H.M.A.S. "SHEPPARTON"
GENERAL ARRANGEMENT
[AS FITTED]
LOWER DECK & HOLD

H.M.A.S. "SHEPPARTON"

SURVEY & CHART ROOM - AFT SUPERSTRUCTURE X

CONSTRUCTION DETAILS

UPPER DECK.

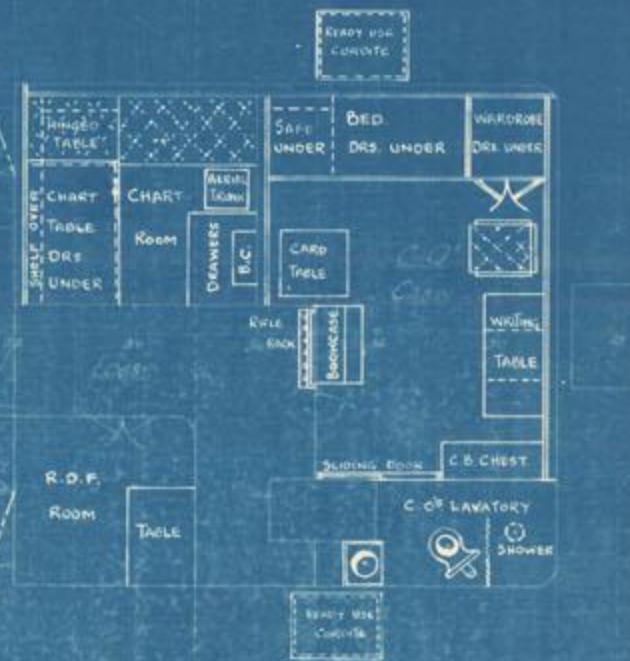
2 POR. GUN FITTED, 4" H.A.Q.F. TO BE FITTED LATER
AND TO REPLACE 12 POR. GUN.

PLAN AT UPPER DK.

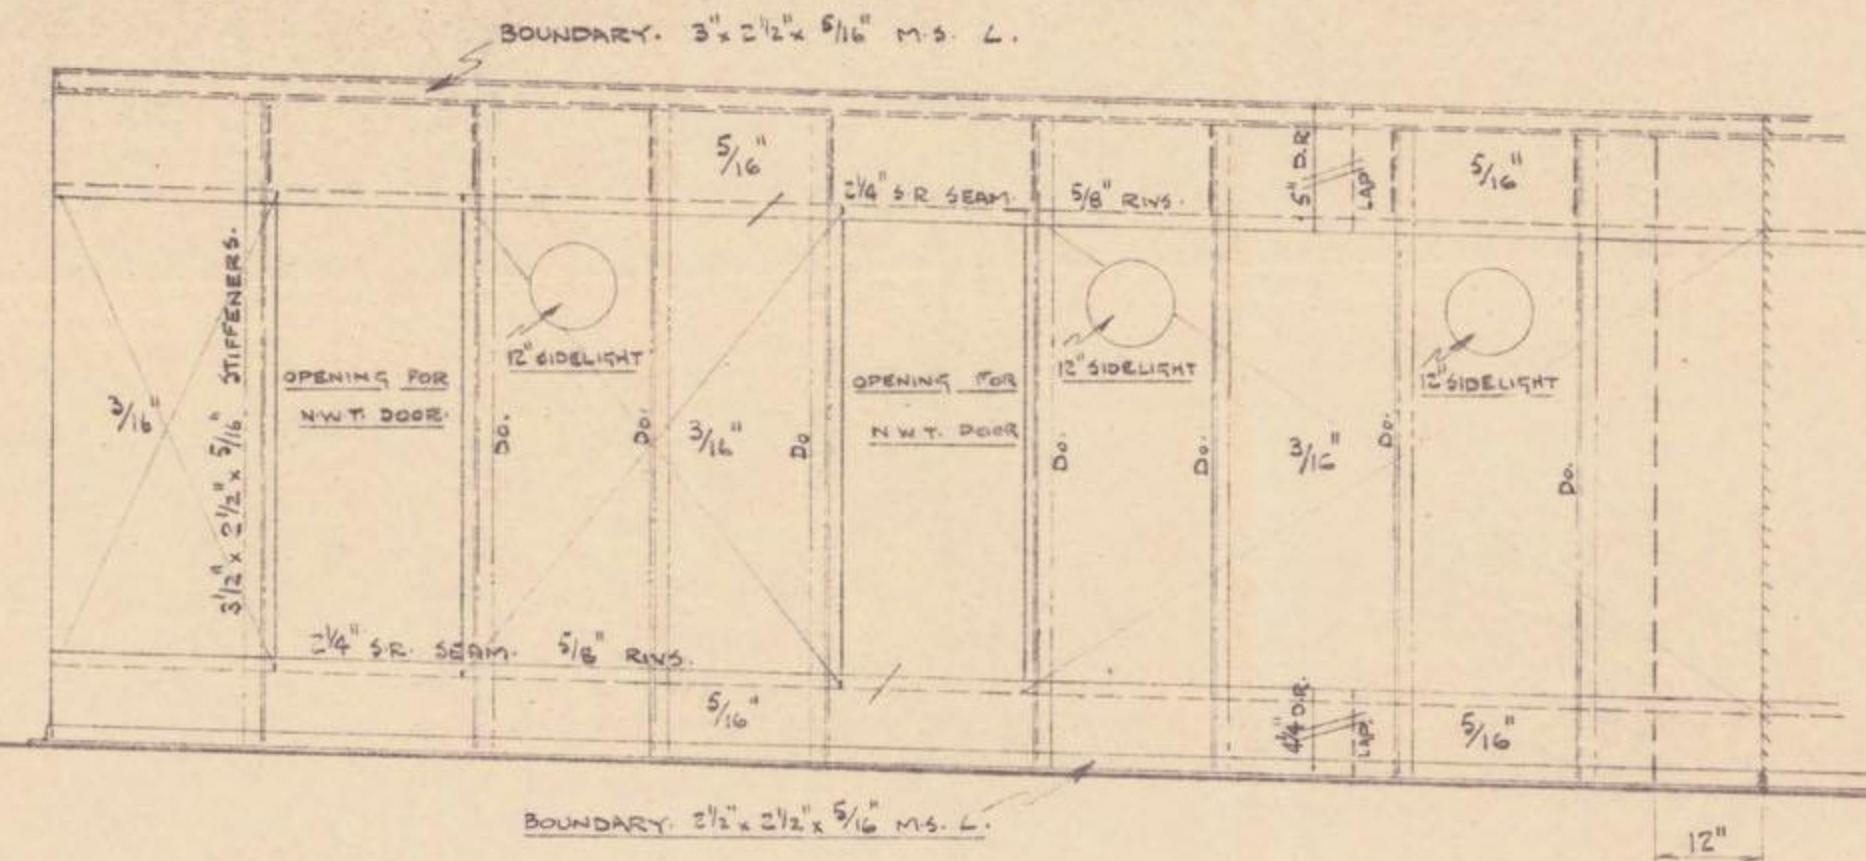
EXTRACT FROM S.M.A.G.I'S LETTER DATED 26/11/53

"The old weather deck timber has been completely removed, including the boundary angle. New coamings and boundary angles were fitted to the deck house to prevent a recurrence of the corrosion. The deck plating has been cleaned and covered with coatings."

FILE 4284/29/53, "Report of Survey of Hull Structure" refers.

False decking removed.

See also GMG.I Letter 2339

16/3/54. (4284-29-40) which officially confirms the above alteration
